Mission Planning and Analysis Division
NATIONAL AERONAUTICS AND SPACE ADMINISTRATION
MANNED SPACECRAFT CENTER
HOUSTON, TEXAS 77058

MEMORANDUM TO: FA/Chairman, Software Control Board

FROM : FM/Chief, Mission Planning and Analysis Division

SUBJECT : Completion of MPAD Action Items from the Apollo 14
Flight Software Readiness Review

VARIATION OF ALTITUDE RATE WITH TGO

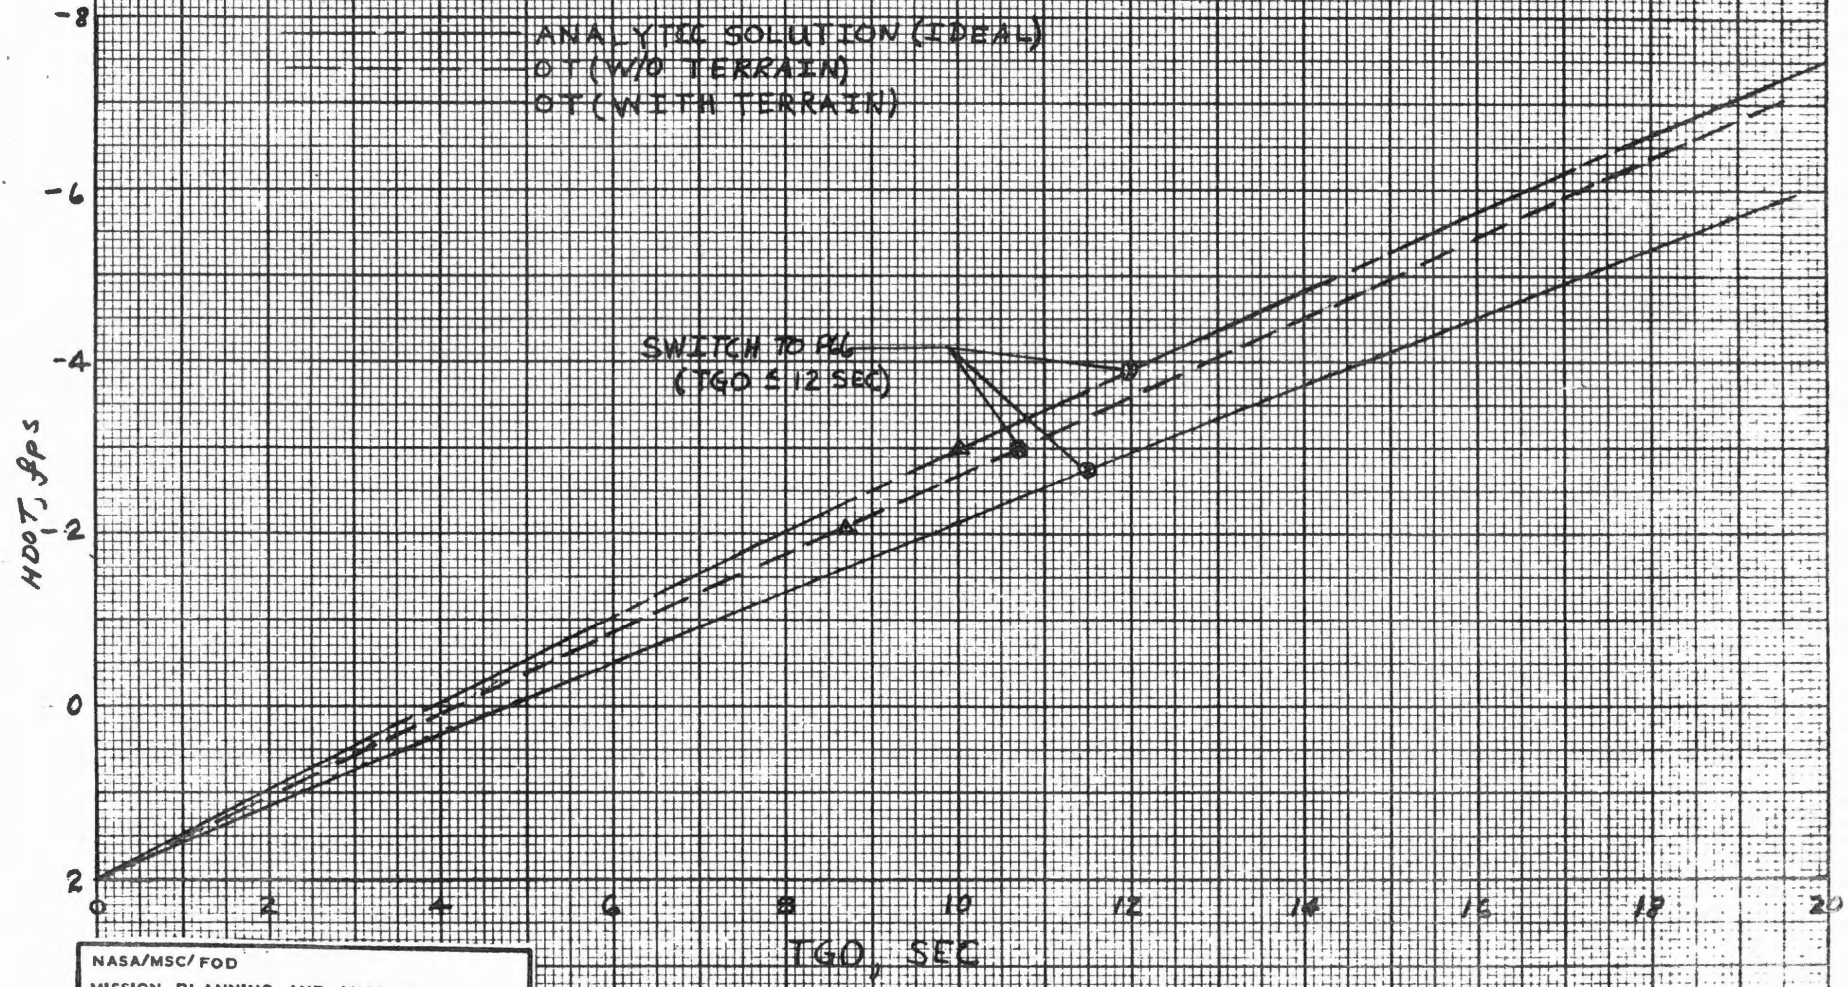
The program switch is initiated when the guidance time-to-go (TGO) is less than 12 seconds with a time delay of 2 seconds. The program is targeted so that a -3 fps descent rate is achieved at 10 seconds (12 seconds minus the 2-second delay). However, because the TGO is only calculated every 2 seconds, the computer timing allows approximately 2 seconds variation in the actual switch TGO. The nominal simulations have been switching at TGO's of less than 10.5 seconds (instead of 12); therefore, the expected rate would be at least 0.75 fps low. In addition to the time delays, terrain perturbations have biased the descent rate profile low (see figure 1) causing the actual rate to be even less.

Figure 1 shows the variation of altitude rate with TGO for several cases. The first case is the analytic (ideal) solution. It would switch at a TGO of 12 seconds and achieve a descent rate of -3 fps at 10 seconds. The second case is an operational trajectory run without terrain switching at 10.7 seconds achieving a rate of -2.2 fps. The third case is the operational trajectory run with terrain. It reached program switch at a TGO of 11.5 with the resulting rate of -2.0 fps.

Similar results were obtained from MIT, GAC, and TRW. However, no change to the Apollo 14 trajectory or guidance programs is recommended. If the Apollo 14 crew chooses to enter auto P-66 in this manner, they can alter the descent rate with the rate of descent (ROD) switch to some other desired rate.

LANDING SITE TRUNCATION ERROR IN THE Y PLATFORM DIRECTION
PER GUIDANCE CYCLE

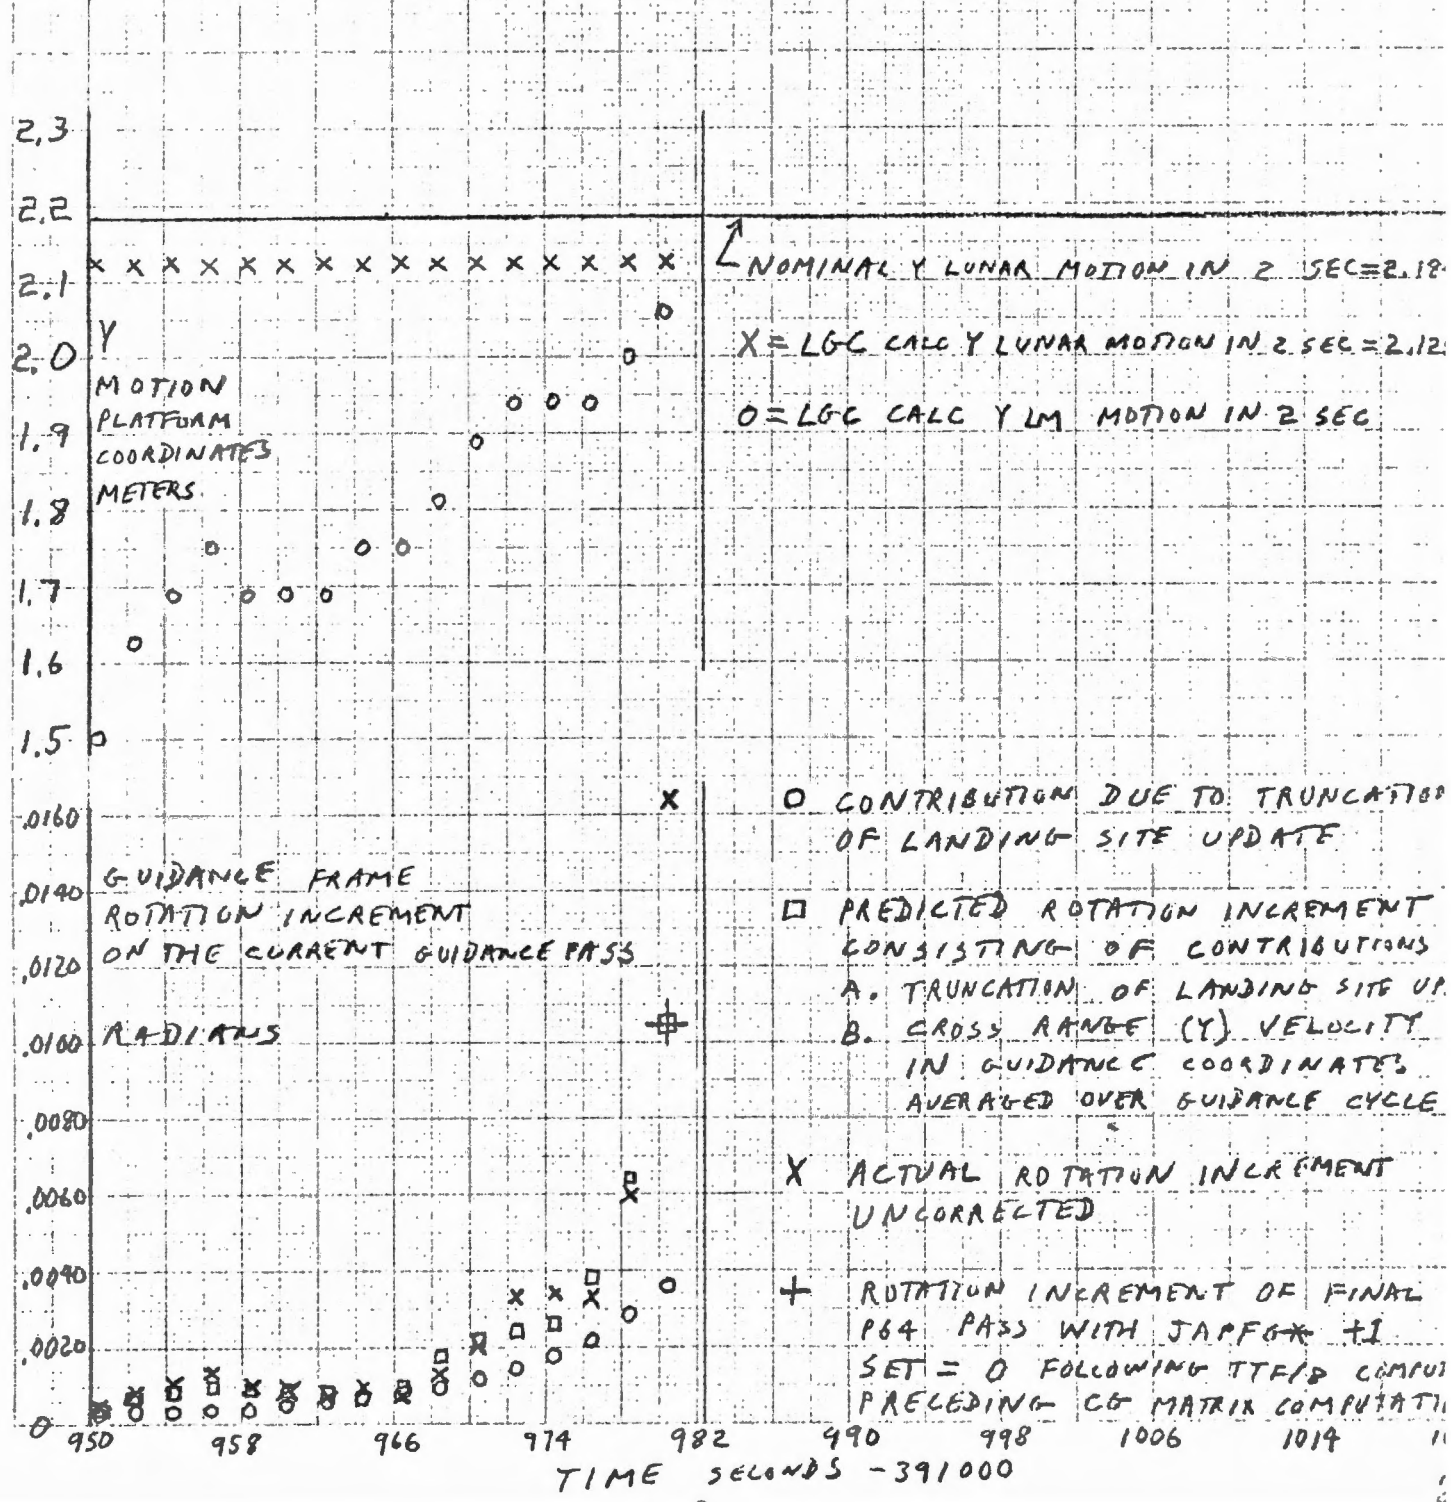
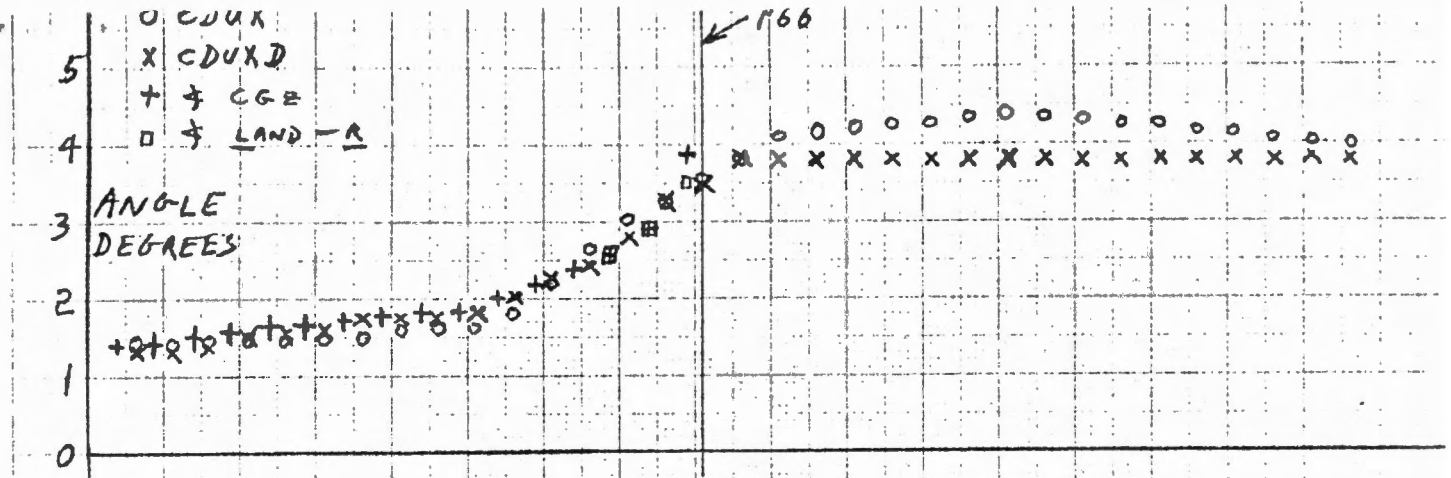
Simulation results have been analyzed to determine whether or not the sources cited explain all of the yaw observed, and we believe they do. Figure 5, illustrating these results, contains three parts. The upper part shows that the yaw angle and the azimuth angle of the guidance coordinate frame follow very closely, as to be expected. The second part of Fig. 5 shows that the landing site does move precisely 2.125 m each 2 seconds, as predicted. The LM motion is also plotted, and it converges on the landing site motion, as expected.

The most interesting revelation of Fig. 5 is the bottom plot which shows the rotation increment of the guidance coordinate frame on each guidance cycle (X) as compared to a predicted rotation increment (\square). The rotation increment is within 1 mr of the prediction every pass except the last P64 pass when the discrepancy is about 6 mr. The discrepancy on this final pass is due entirely to the mistakes in the LGC coding; when the LGC coding is patched to correct the effect of the mistakes, the discrepancy becomes zero, i. e. the prediction (\square) coincides with the rotation increment (+).

This lower section of Fig. 5 also separates the individual contributions to guidance coordinate frame rotation. The circles display the rotation increment contributions due to landing site truncation, and the squares represent the combined effects of landing site truncation and cross-range velocity. In this simulation, the contributions are about equal except the cross-range velocity becomes dominant near the close of P64. The truncation contributions were computed by dividing the truncation error by the current range. The cross-range velocity contributions were computed by averaging the Y components of velocity in guidance coordinates at the start and finish of the current guidance cycle, multiplying by the 2 second guidance period, and dividing by the current range. The maximum prediction error, (X) - (\square), is under 1 mr and corresponds to under 1 bit error in position.
